Access Compliance Report

Public Rights-of-Way (Curb Ramps)

Intersection ID: 50763	Main Street: QUIET_CREEK_CR	Cross Street: SCOTT_CREEK_DR	Location: NW
ADA ID: ABA263206C77	Ramp Type: Perp	Initial Pass/Fail: Fail	Overall Compliance: No
Severity Score: 8.75			
Codes/Mitigation Info/Possible Solution		Field Measurements/Component Compliance

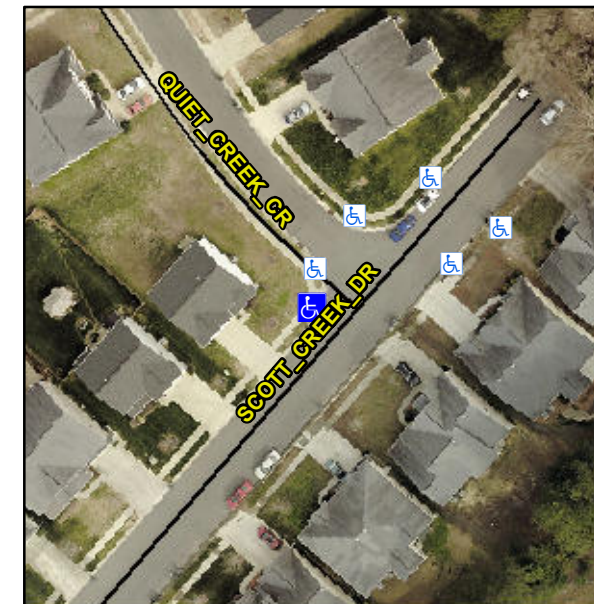
R304.5.1

Compliance	Description	Data	Compliance	Description	Data
N/A	Ramp Length (in)	46.5	Yes	Ramp Slope (%)	7.0
No	Ramp Width (in)	47.0	Yes	Ramp XSlope (%)	1.8
N/A	Flare Type LT	N/A	N/A	Flare Type RT	N/A
N/A	Flare Slope LT (%)	N/A	N/A	Flare Slope RT (%)	N/A
N/A	Flare Traversable LT?	N/A	N/A	Flare Traversable RT?	N/A
N/A	Landing Length (in)	N/A	N/A	DWS Provided?	N/A
N/A	Landing Width (in)	N/A	N/A	DWS Contrast?	N/A
N/A	Landing Slope (%)	N/A	N/A	DWS Length (in)	N/A
N/A	Landing X Slope (%)	N/A	N/A	DWS Full Width?	N/A
N/A	Landing Curb? (Y/N)	N/A	N/A	DWS Offset (in)	N/A
N/A	Shared Landing?	N/A			
N/A	Gutter Ponding?	N/A	N/A	Gutter Slope (%)	N/A
N/A	Gutter Lip Ht (in)	N/A	N/A	Gutter X Slope (%)	N/A
N/A	Painted X Walk1?	No	N/A	Painted X Walk2?	N/A
	X Walk 1 Direction	To S		X Walk 2 Direction	N/A
N/A	X Walk 1 Width (in)	N/A	N/A	X Walk 2 Width (in)	N/A
	X Walk 1 Slope (%)	2.1		X Walk 2 Slope (%)	N/A
	X Walk 1 X Slope (%)	1.6		X Walk 2 X Slope (%)	N/A

Remove & Replace Entire Ramp.
